## BOARD OF COUNTY COMMISSIONERS ORANGE COUNTY, FLORIDA

# Y17-736-MM / ADDENDUM # 1 ORANGE COUNTY CONVENTION CENTER NORTH/SOUTH BUILDING DEMARC, MDR AND MDF ROOMS HVAC UPGRADES

### New Bid Opening Date: March 23, 2017

AND SCHEDULES SHEET INFORMATION: JOB No. **100046579** Date Issued: JANUARY 18, 2017 **M-201** TJF Phase: 100%

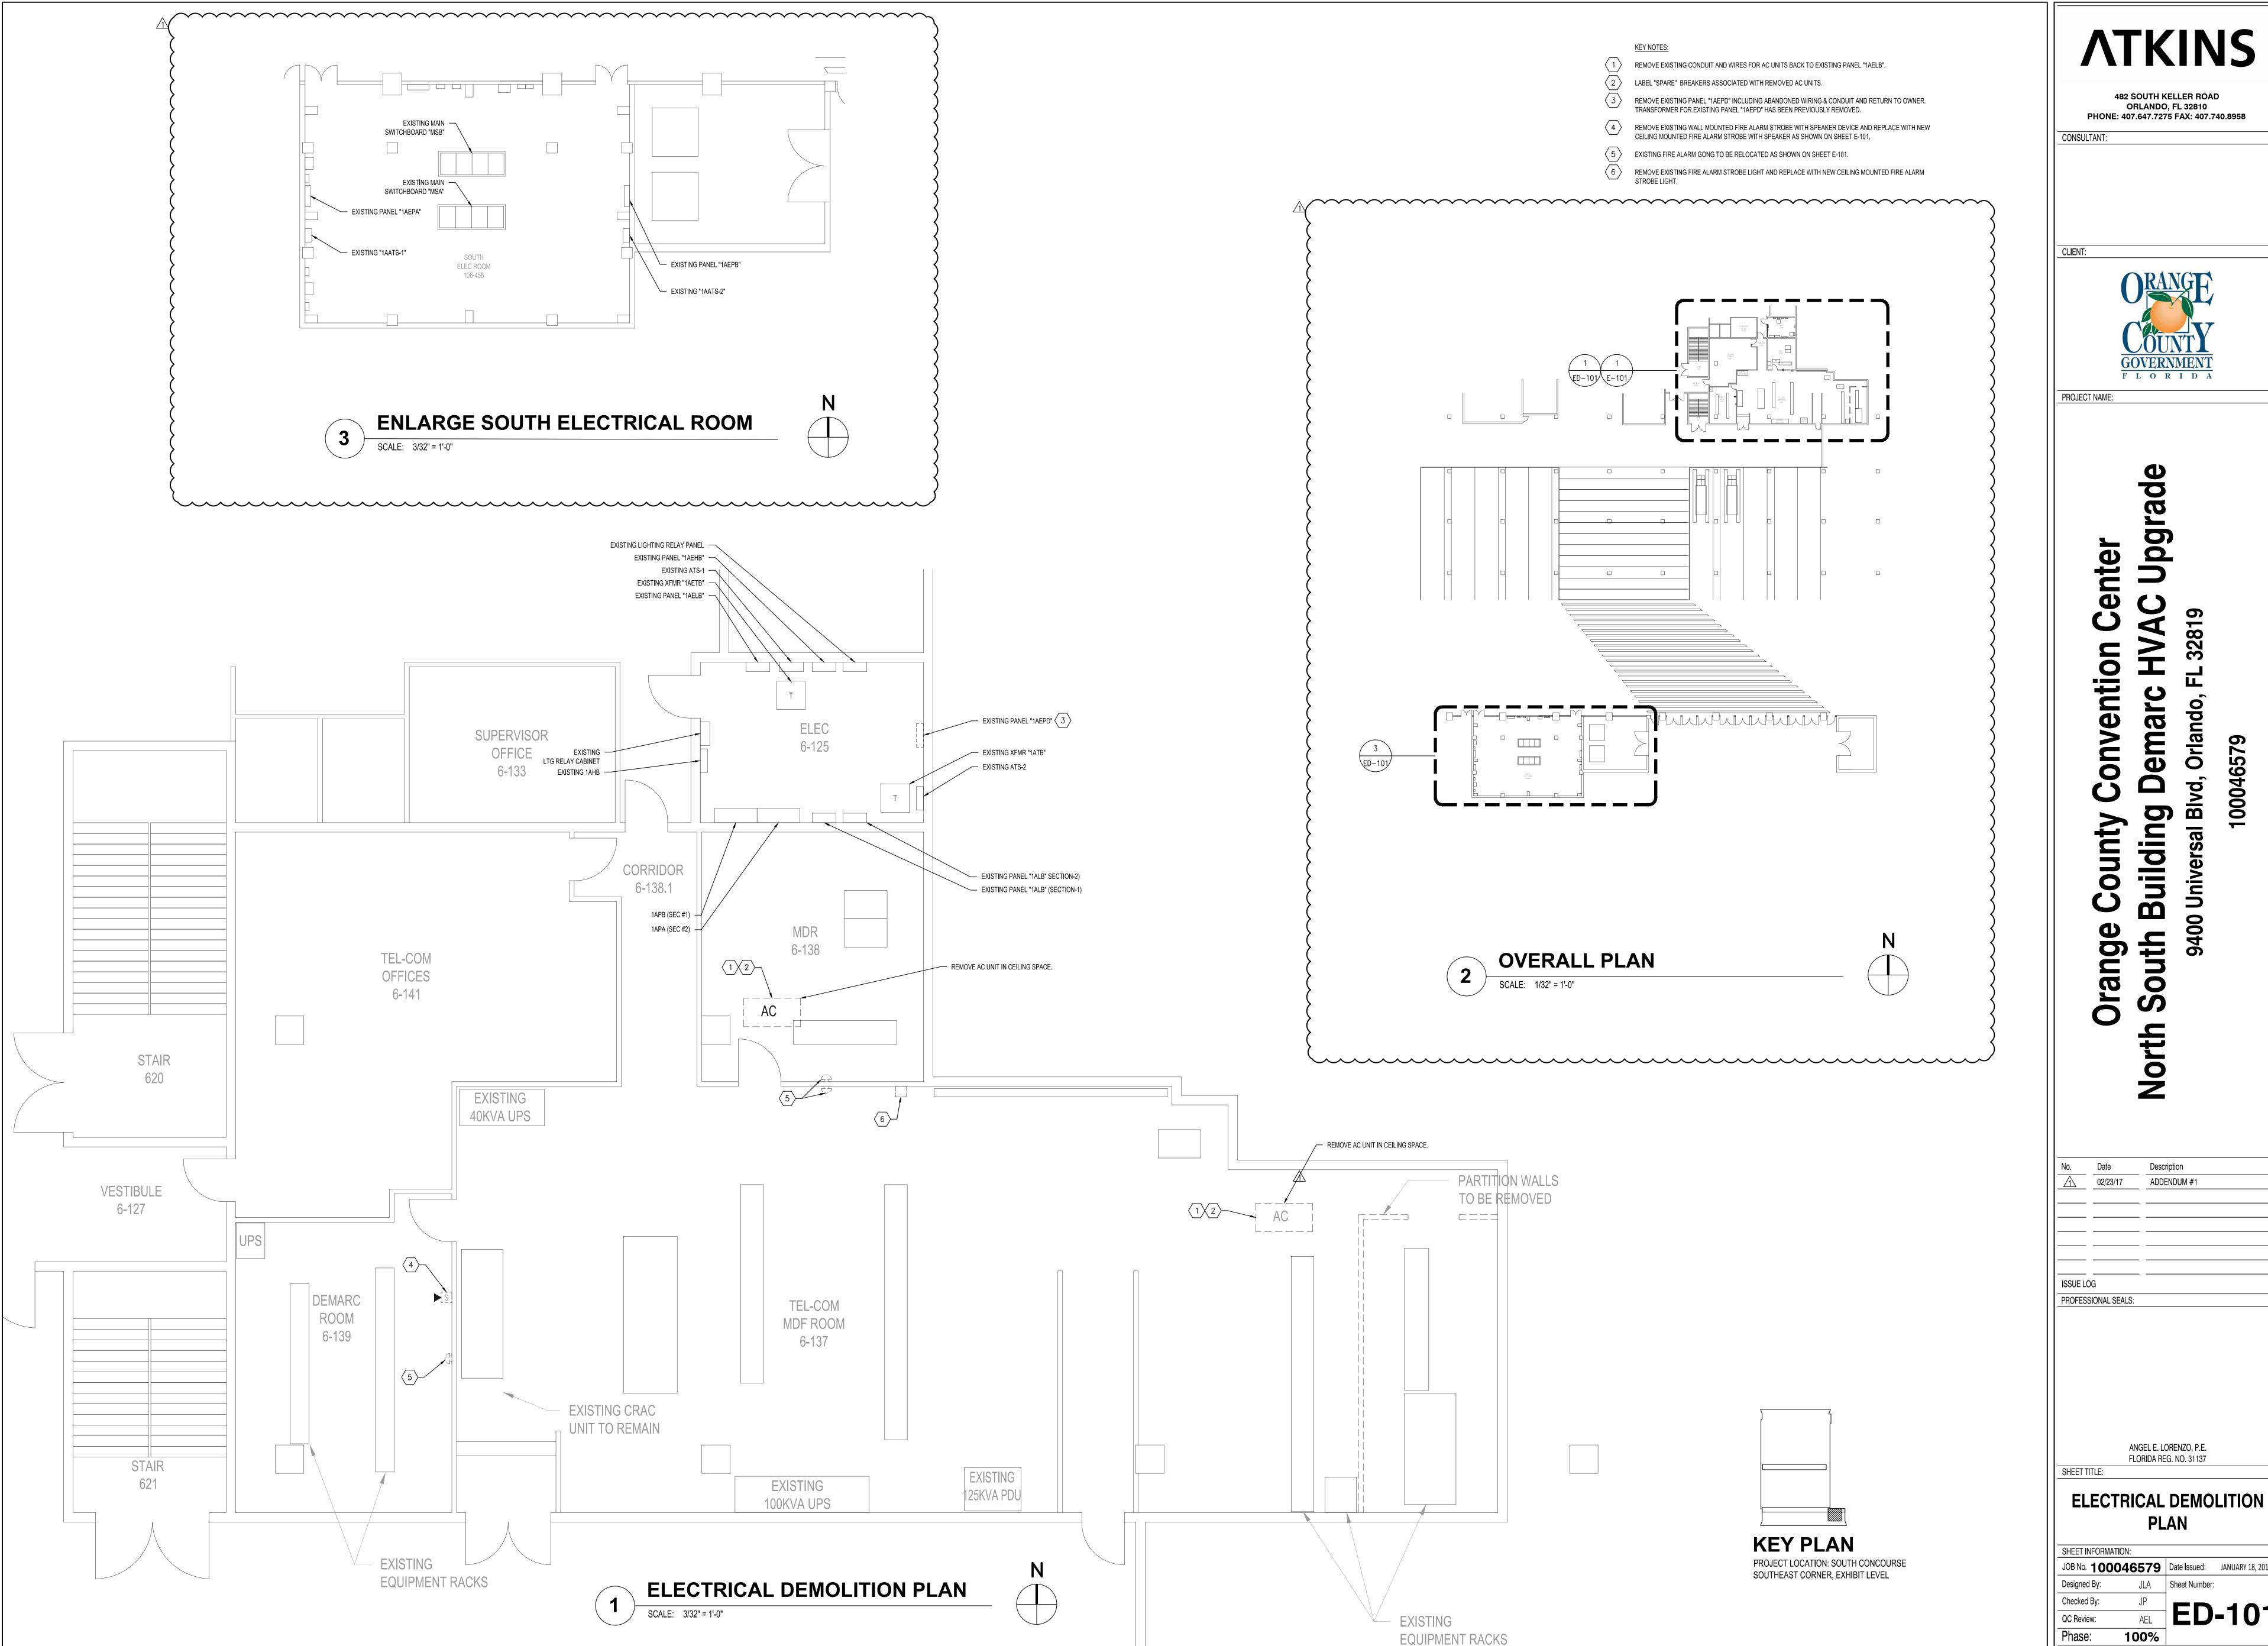
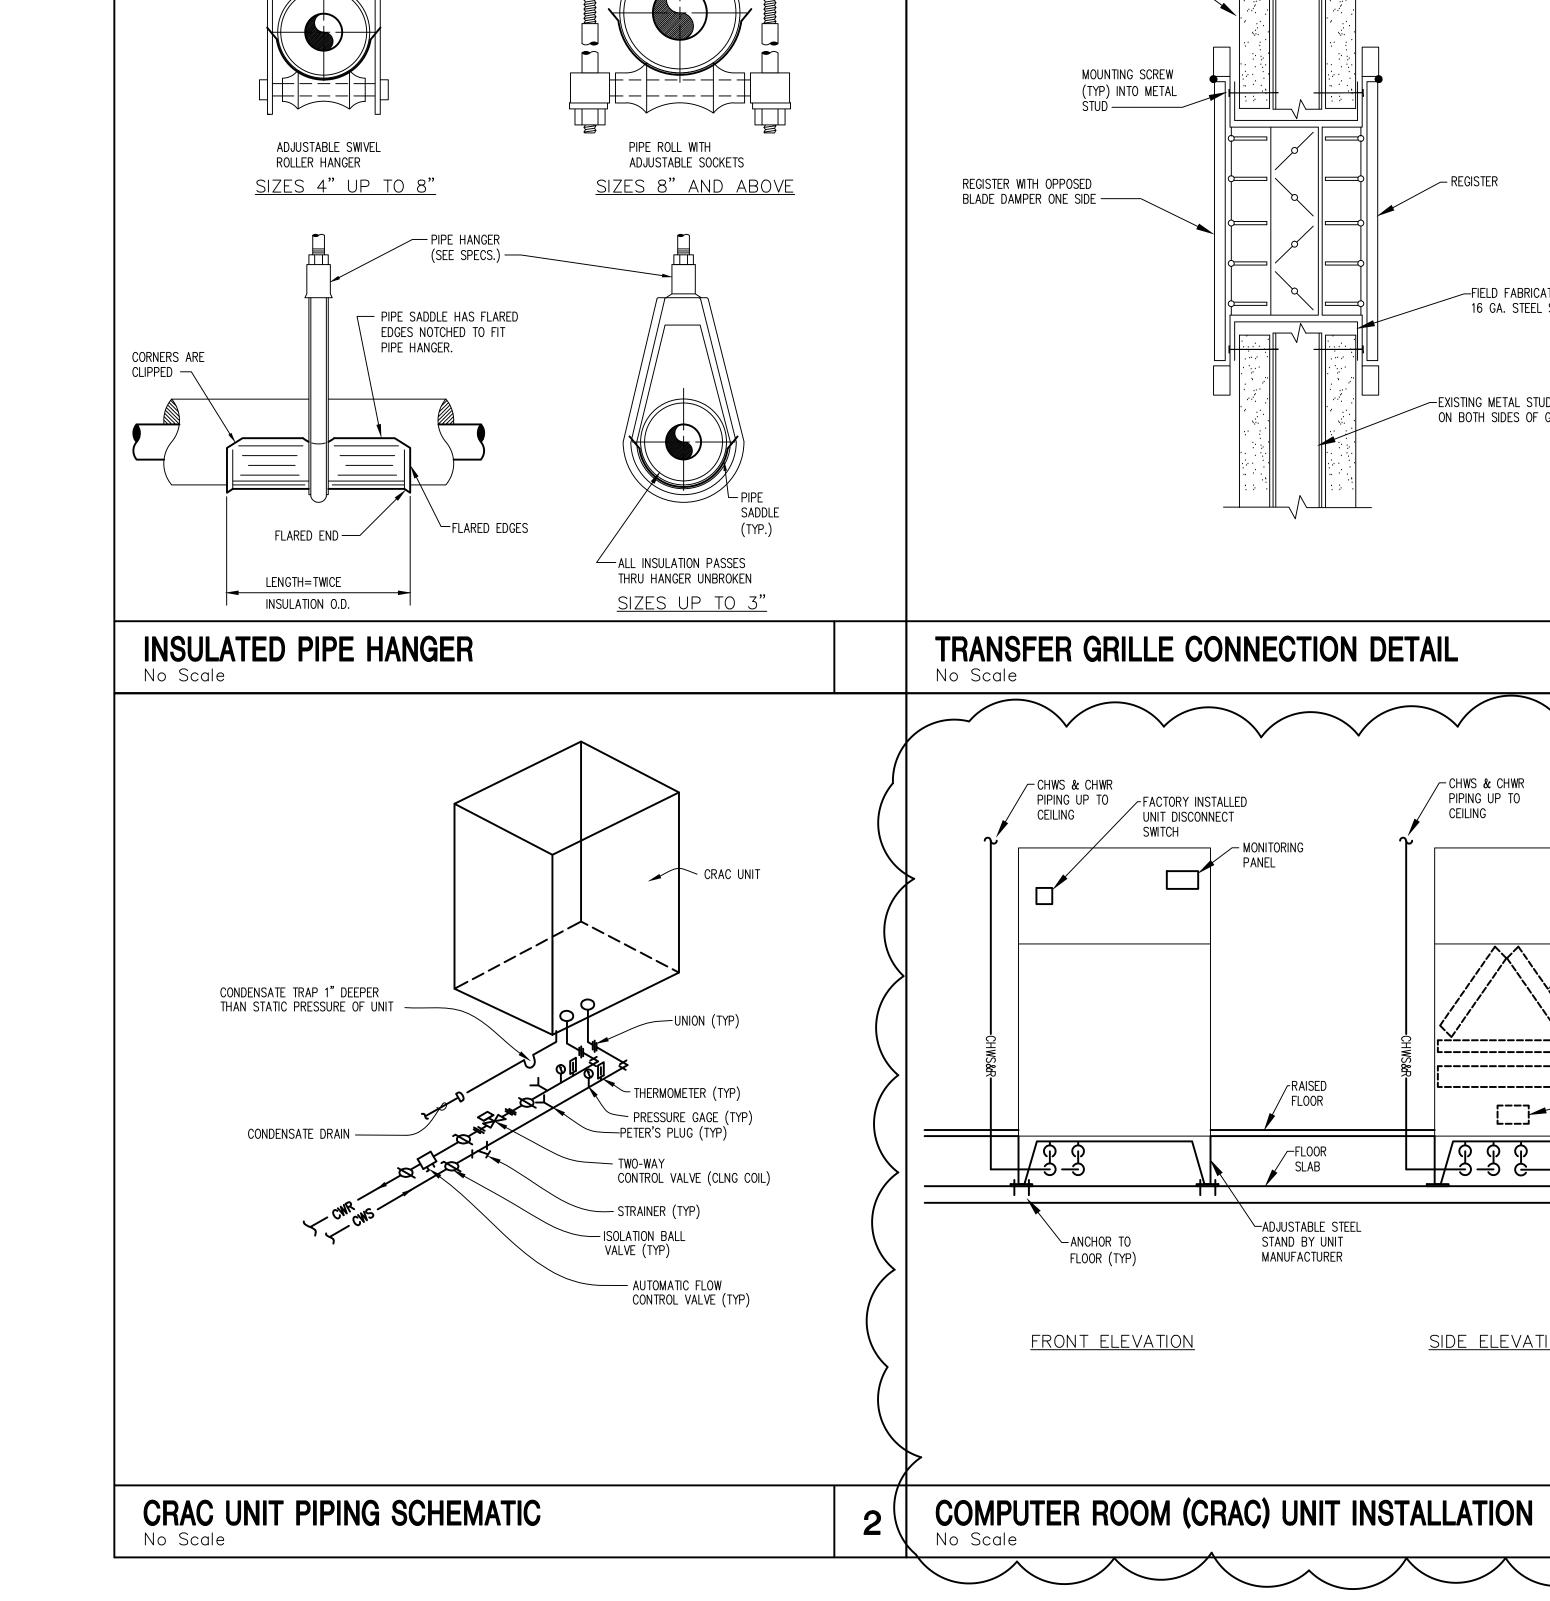
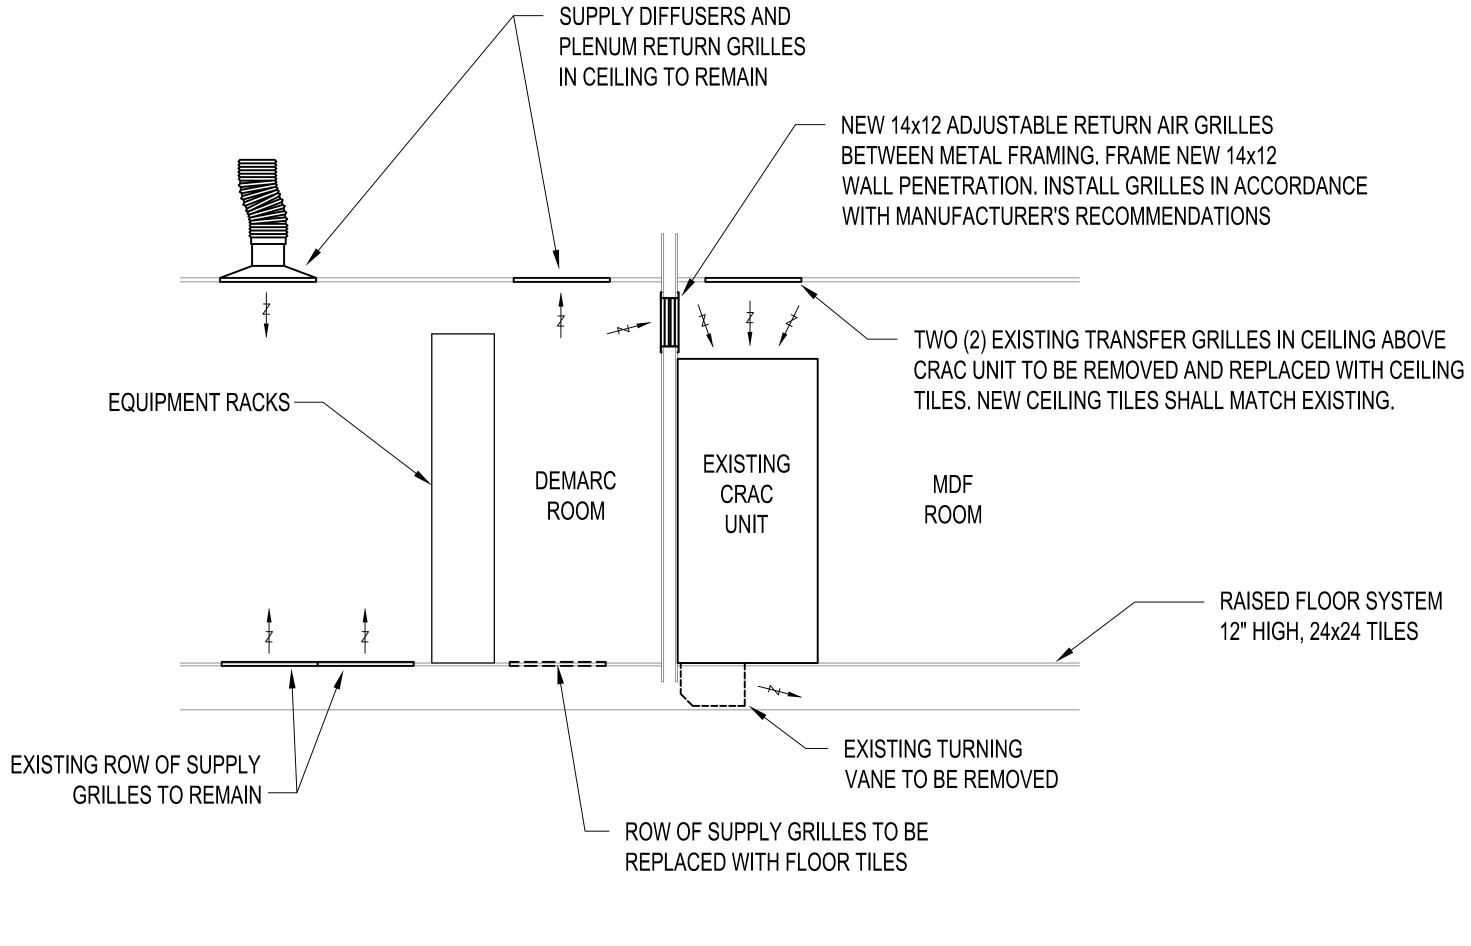
- 1. **Comment:** Provide a mounting detail for the new CRAC units. **Response:** Detail #4 added to attached revised drawing sheet M-201.
  - 2. **Comment:** Provide new equipment weights. **Response:** New CRAC unit weights added to Computer Room Unit Schedule on attached revise drawing sheet M-201.

- 3. **Comment:** Provide a secondary drain for the new CRAC units. **Response:** Primary and secondary drains with floating switches have been included per Note 4 of the CRAC Computer Room Unit Schedule on attached revised drawing sheet M-201.

- 1. M-201: Added Detail # 4.
  - 2. M-201: Added CRAC units weight to Schedule.
  - 3. M-201: Revised Note 4 to include drains for CRAC units.
  - 4. ED-101: Added Main Electrical Room plans.

4. PROVIDE EC PLUG FANS, 12" FLOOR STAND, MERV 8 FILTERS, FACTORY MOUNTED CONDENSATE PUMP WITH INTEGRAL PRIMARY & SECONDARY

FLOAT SWITCHES, SMOKE SENSOR, FACTORY INSTALLED LOCKING DISCONNECT SWITCH AND PERIMETER WATER DETECTION SYSTEM.
